MARK	DATE	DESCRIPTIONS	BY	CH'D	CCO#
3	04/25/08	ELECTRICAL MODIFICATIONS	AS	MN	42
2	04/18/08	BARRIER MODIFICATIONS	AS	MN	44
1	08/24/07	BARRIER MODIFICATIONS	GB	MN	44

CONTRACT CHANGE ORDER NO. ____
SHEET ___ OF ___

SAN FRANCISCO OAKLAND BAY BRIDGE
EAST SPAN SEISMIC SAFETY PROJECT
SELF-ANCHORED SUSPENSION BRIDGE
(SUPERSTRUCTURE & TOWER)

UTILITY DETAILS NO. 2

DETAIL A
SPARE PENETRATIONS SEALING DETAIL
(As required, see Note 6)
1:2.5

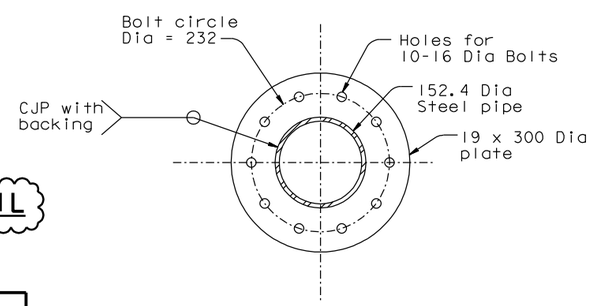
6. For each Doubler PL the Contractor shall provide four penetrations of the doubler and tower skin plates. For conduits installed under this contract the Contractor shall determine a hole size suitable to the installed conduit. The remaining penetrations shall be 100 mm diameter and shall be sealed. See Detail A. 3
